KF110816- C015

Re SSD 5300 Resource Recovery Facility, 30 Wyllie Road, Kembla Grange

I understand that an application to modify SSD5300 is being prepared. The purpose of the application is to install a weighbridge office in order to increase the efficiency and safety of weighbridge operations.

DRAINS Model
100yr ARI with new Weighbridge Office

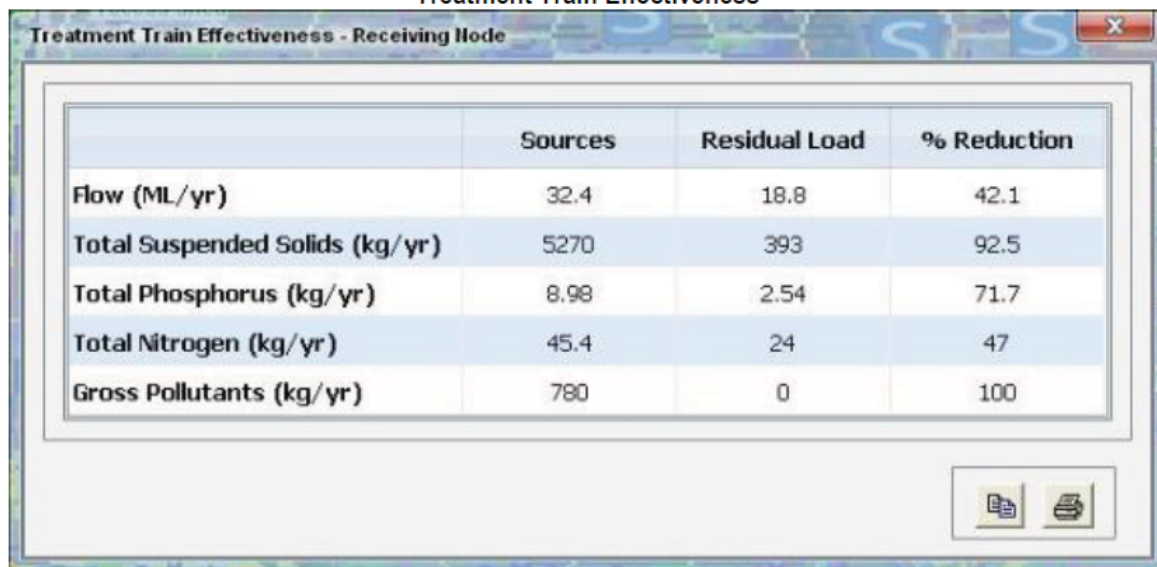
Reference to Attachment #1 indicates the following:

- o Peak local runoff at pit 1G increases in from 0.153 m³/s to 0.155 m³/s during a 100yr ARI storm burst.
- o No increase in discharge from the detention basin. Site discharge remains at 0.359 m³/s with 0.007m³/s weir flow for a 100 year ARI storm burst. The additional 0.002m³/s from Pit 1G is routed through the detention basin and has no effect of site discharge.
- o The proposed weighbridge office and associated site works will not increase the peak runoff from the site.

A2.1 Treatment Train Effectiveness

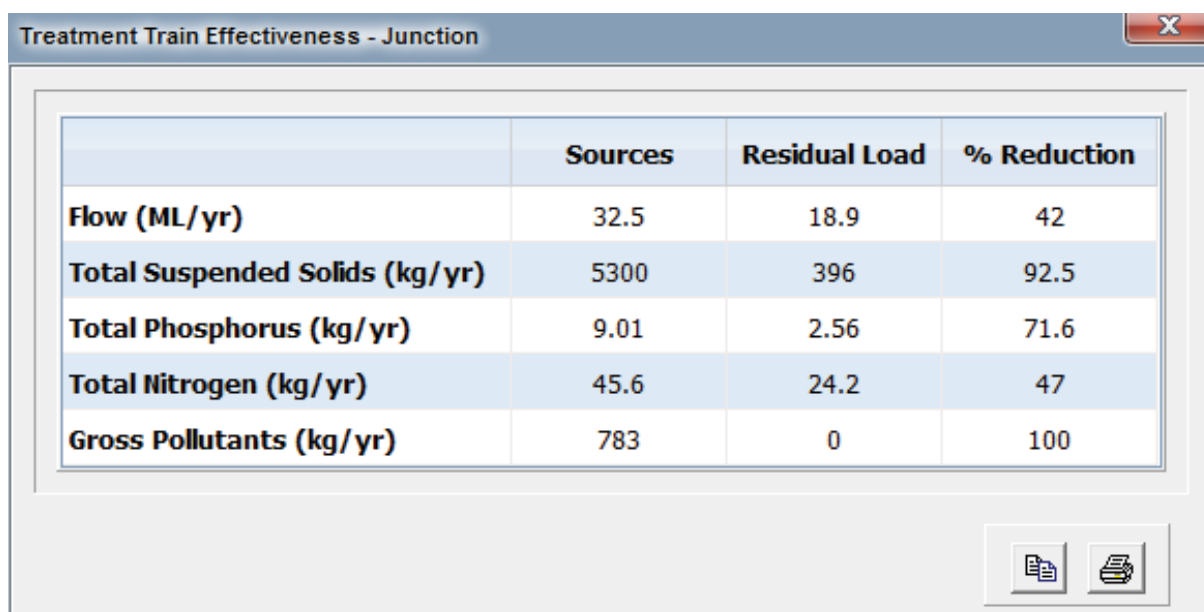
Reference to Attachment #2 indicates the following

- ❖ Table A2.1 shows that there is no perceptible increase residual pollutant load.
- ❖ Table A2.2 shows that water reuse demand met from the permanent pool is largely unaffected. The apparent reduction (ie 75.1% to 74.8%) is due to the weighbridge rainwater tank intercepting runoff which would have otherwise been captured by the permanent pool.
- ❖ Table A2.3 shows that the installation of a 500 litre rainwater tank will provide a small but additional source of water for site operations and mitigate the increase in runoff volume.

Attachment #3: Drawing KF110816 C301 Rev C

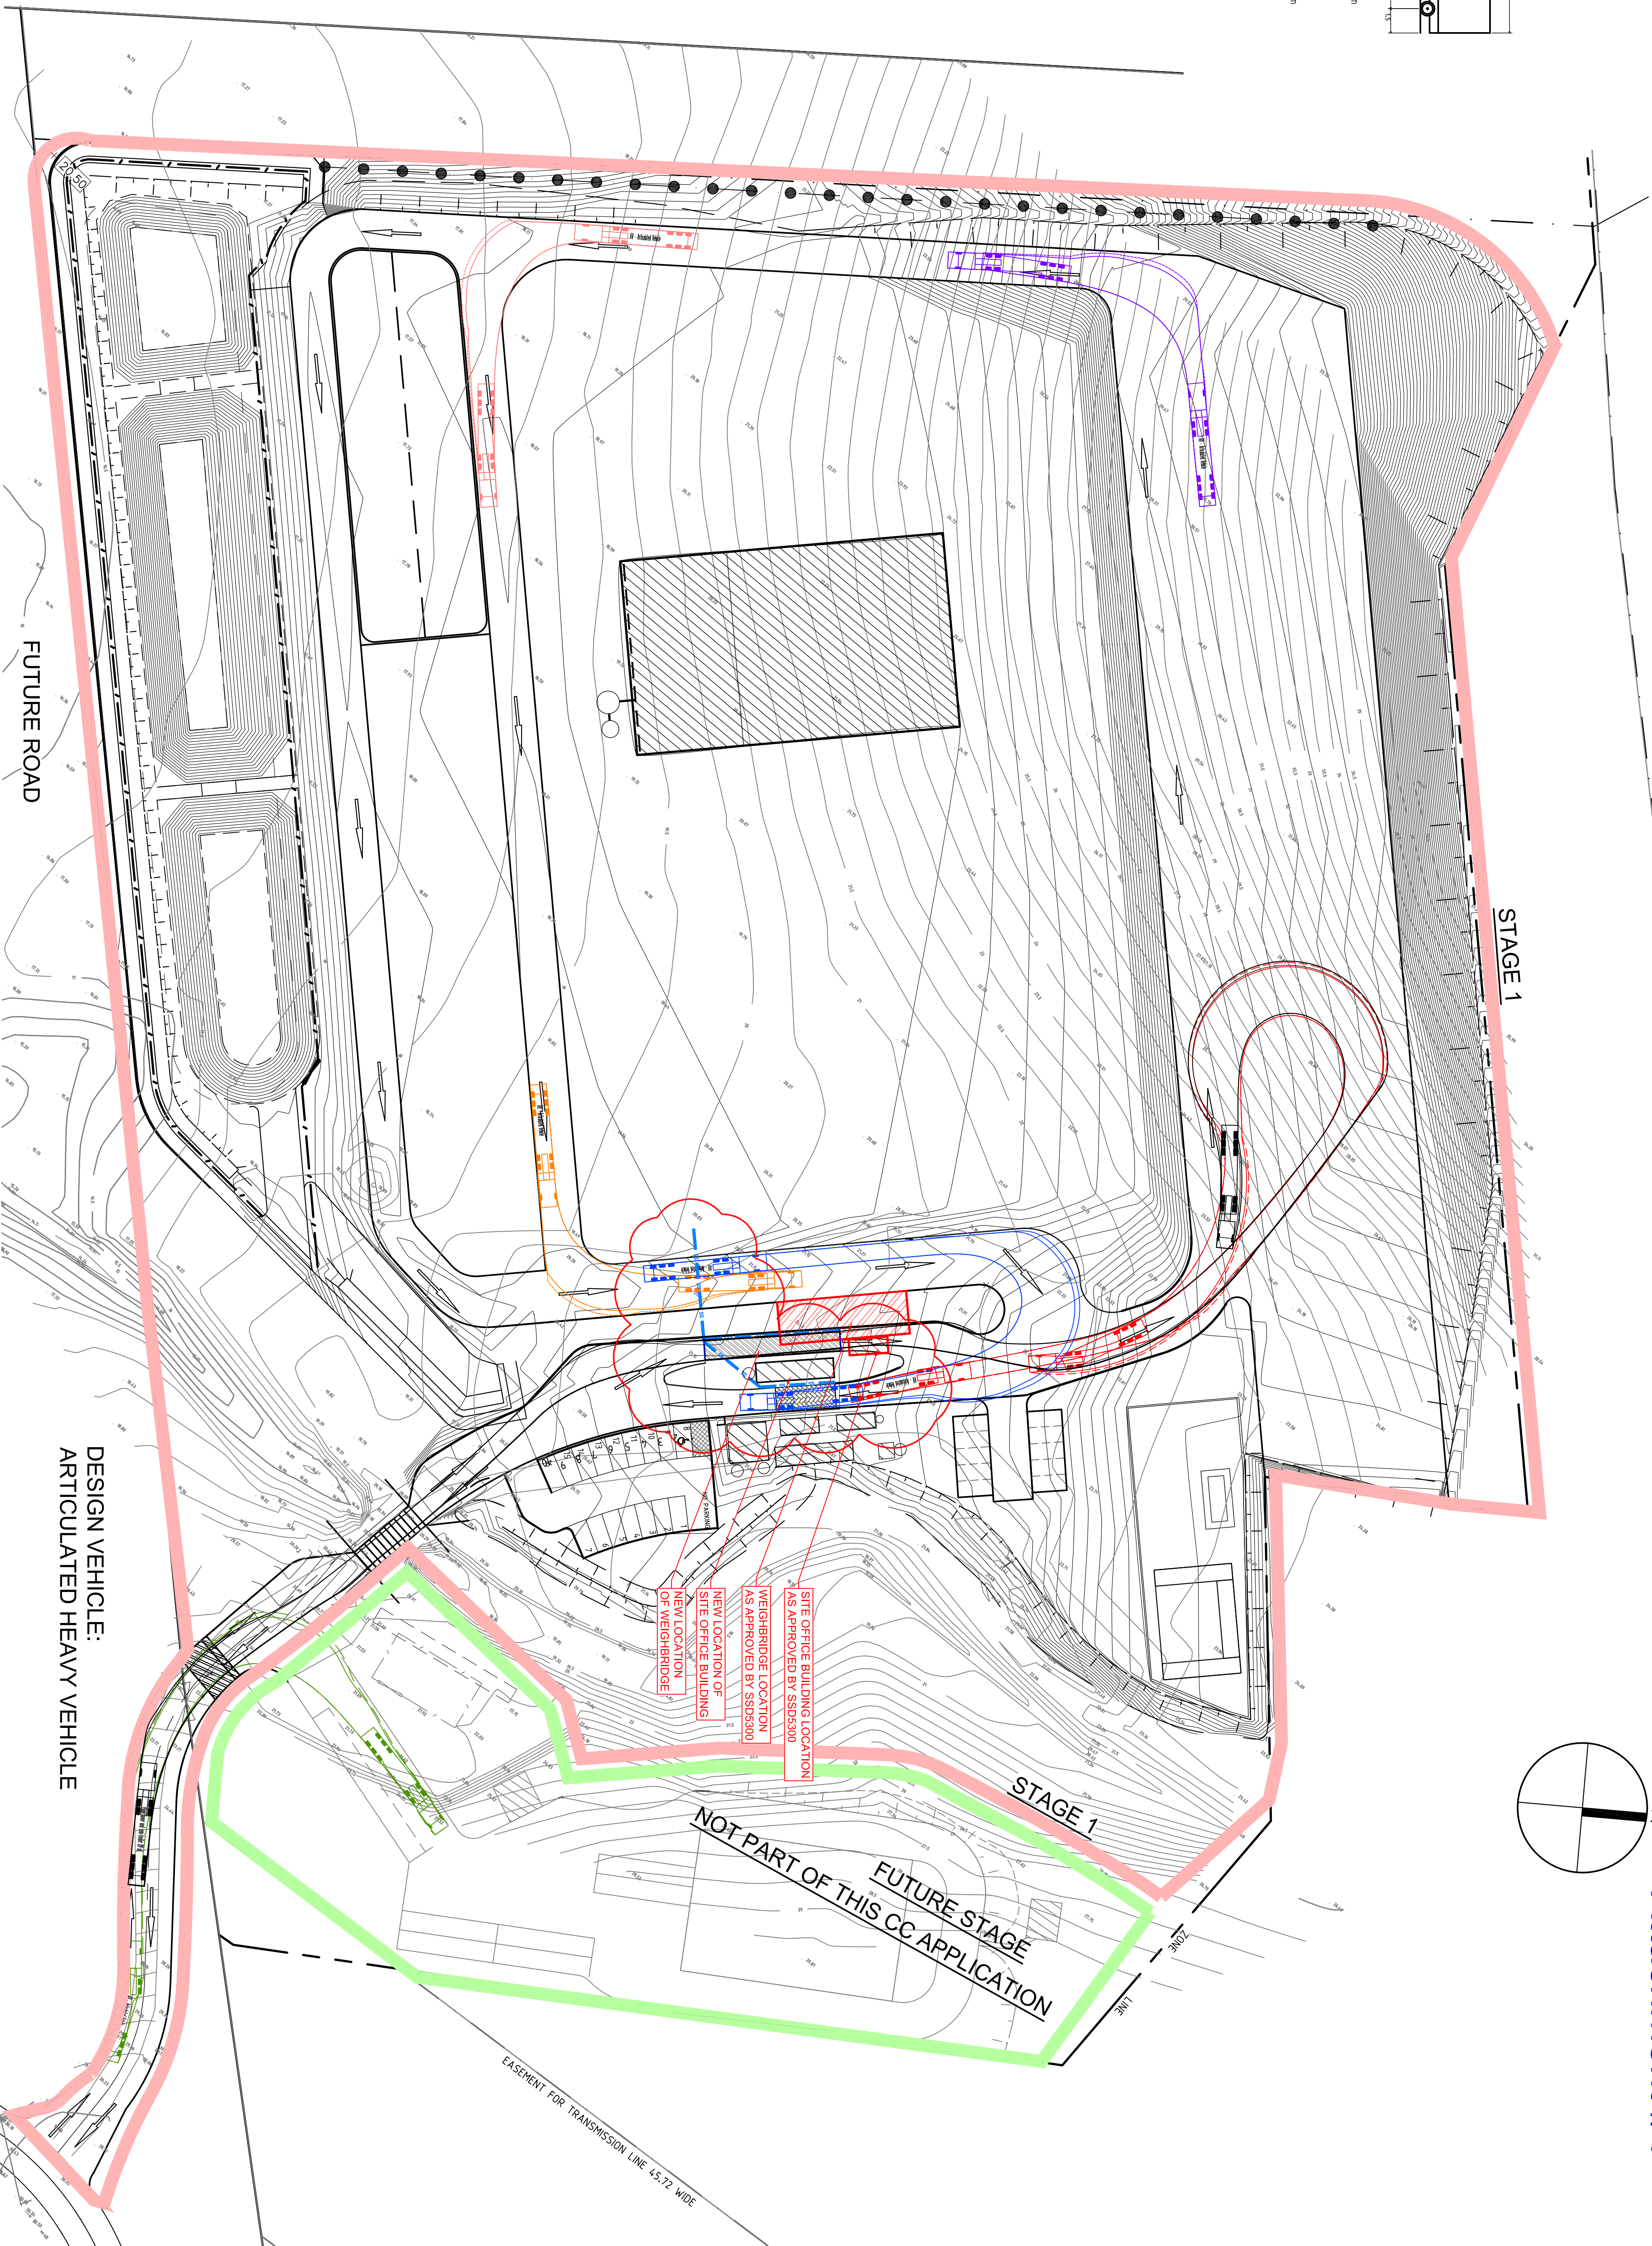
- ❖ Attachment #3 indicates that the weighbridge is well above the 1% AEP flood level and is above the 1% AEP flood level with allowance for climate change.
- ❖ Attachment #4 has been modified with a new swept path showing a heavy articulated vehicle entering the weigh bridge and moving off to the vehicle turning and backing area. The other swept paths presented on this drawing demonstrate that sufficient manoeuvring is available and the new weigh bridge does not restrict vehicle turning and manoeuvring on the site.
